Breakout Rev[F] SCH to PCB Differences

The schematic on p35 thru p42 of the Breakout Operation, Maintenance, Service Manual (TM-058, 4th printing) shows Rev[F]. This schematic does not perfectly match Rev[F] circuit boards. This document details the differences. Naturally we modify the schematics to match the boards because the boards ... work.

Diff-12: @ [S#3-A5/A6] - Free Game Wiring Different

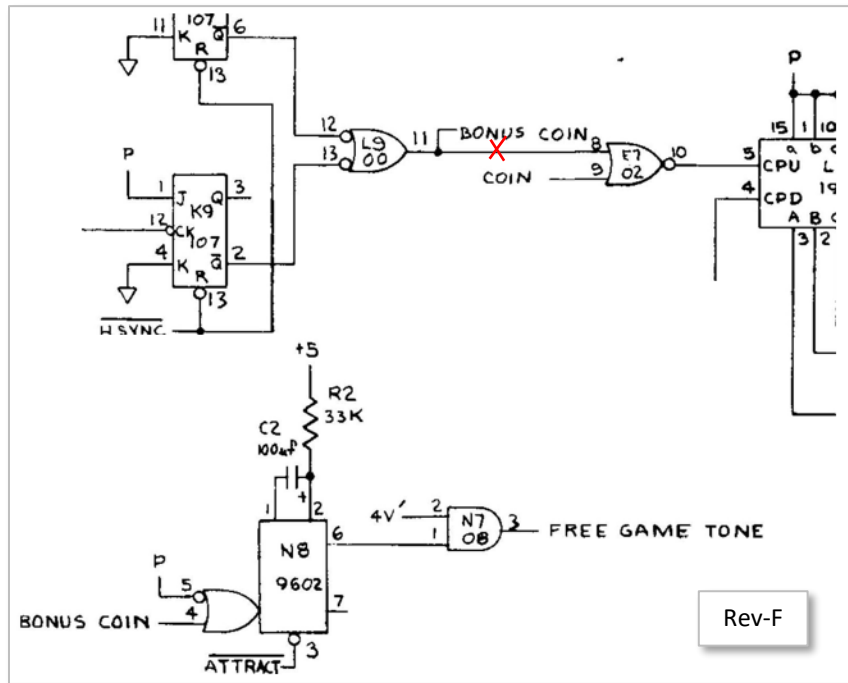
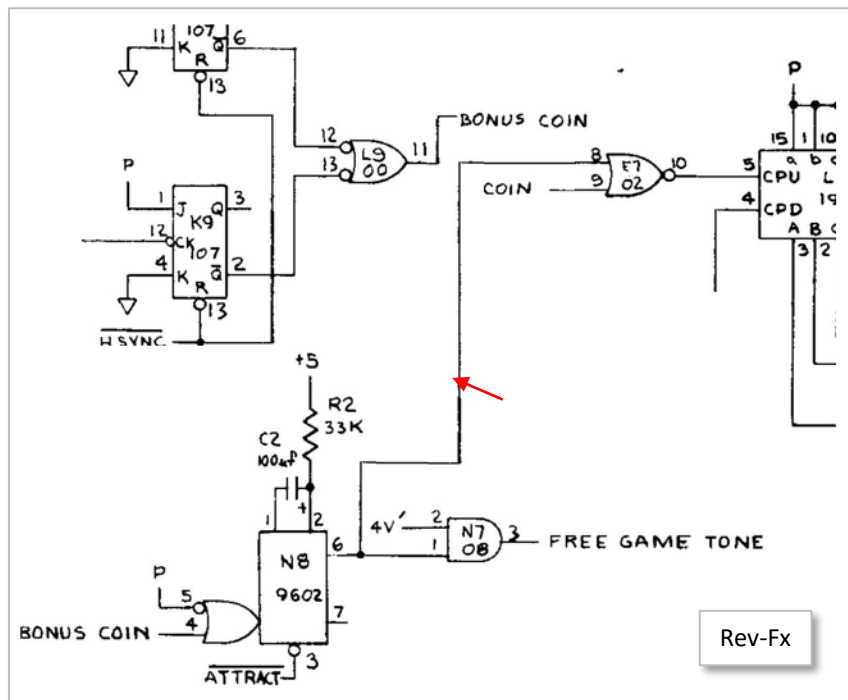
Schematic shows these elements (cropped for relevance), where L9.11 drives E7.8.

On the PCB, N8.6 drives E7.8.

Mod-1: @ [S#1-B7] 4.7K pull-up on brick storage RAM (optional modification)

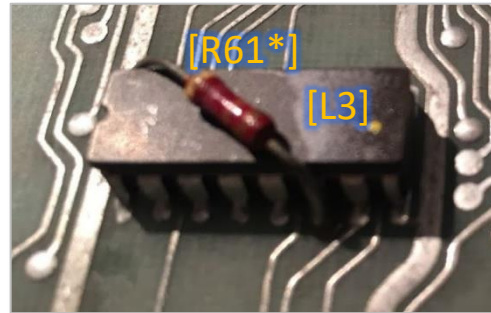
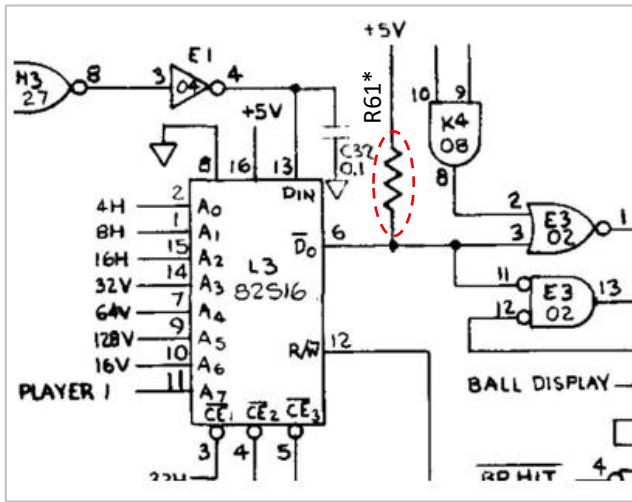
This is not a Rev-F SCH to PCB difference but on some boards, you can clearly see a 4.7Kohm pull-up resistor soldered between L3.6 and VCC. Most likely present when open-collector output versions of the BiPolar RAM (e.g. 82S17) are used. Will be added as an optional part in the retro PCB as R61*.

Note-1 @ [S#1-D4] R51 & R52 are swapped on the schematic (or PLAYFIELD and SCORE)

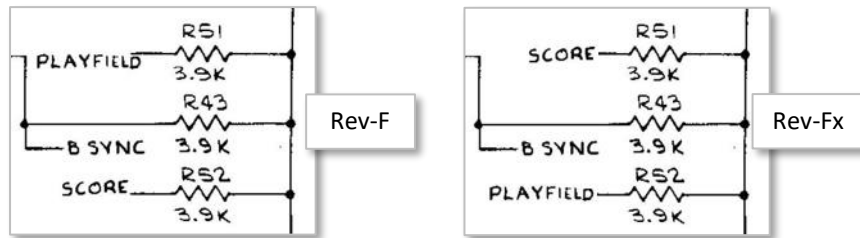
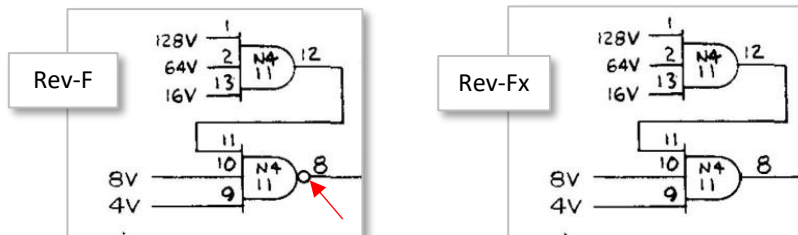
- R51 is driven by PAYFIELD in the schematic but by SCORE (D3a.5) on the PCB.
- R52 is driven by SCORE in the schematic but by PLAYFIELD (H4a.3) on the PCB.

Note-4: [S#2-C7] N5 labeling

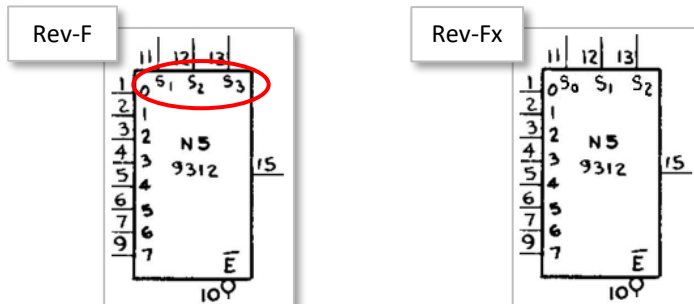
[N5] pins 11, 12, 13 are labeled S1, S2, S3 while all other 9312s are labeled S0, S1, S2

Note-5: [S#2-C7/B7/A7] Output Labeling

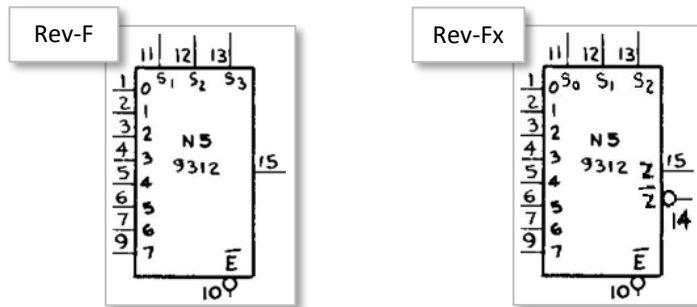
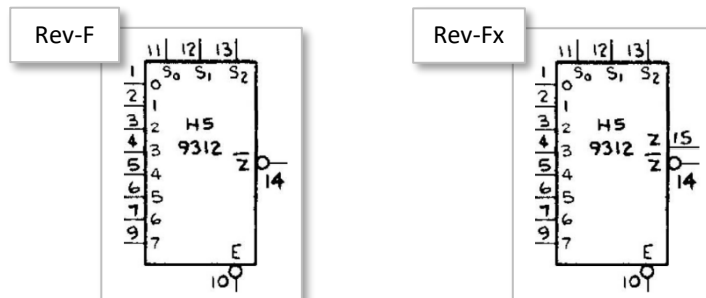
[N5, M5, L5, K5] the Z output is not labeled. Also added the unused !Z output for clarity.

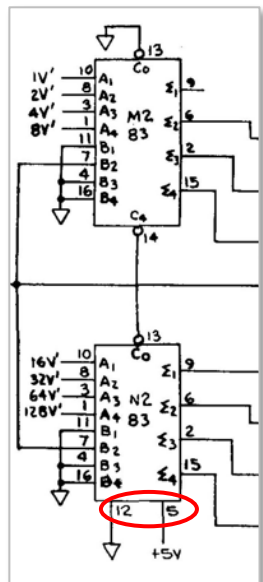
- Misc-4 @ [S#2-B5]: Unused input [N8]-15 (-C) not shown on the schematic and is unused on the PCB. This pin is internally tied to GND inside the 9602 so we include it in Rev-Fx.

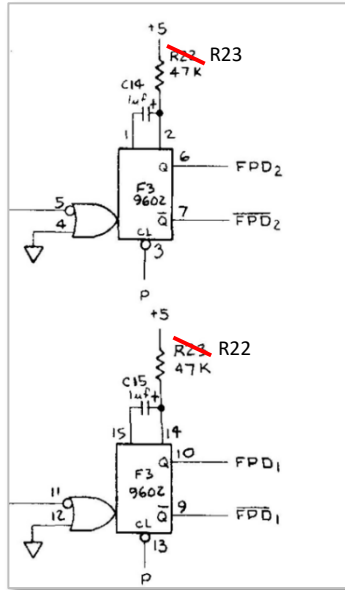
- Misc-6 @ [S#2-D4]: Resistors R22 and R23 are swapped on the schematic. R23 goes to [F3a].2 while R22 goes to [F3b].14 on the board.

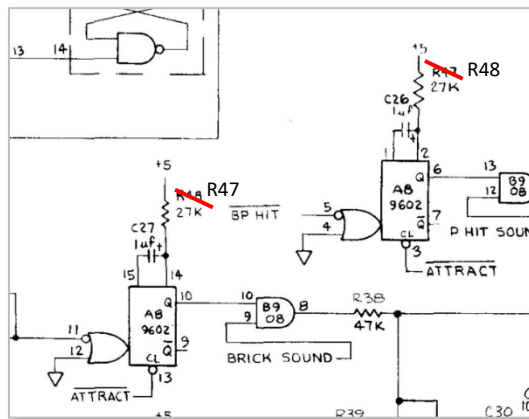
- Misc-7 @ [S#2-D2/3]: Resistors R47 and R48 are reversed on the schematic. R48 goes to [A8a].2 while R47 goes to A8b].14 on the board.

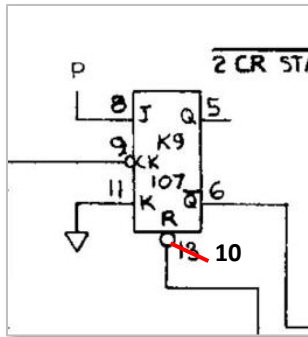
- Misc-8 @ [S#3-B5]: K9b reset line s.b. labeled pin 10, not pin 13.
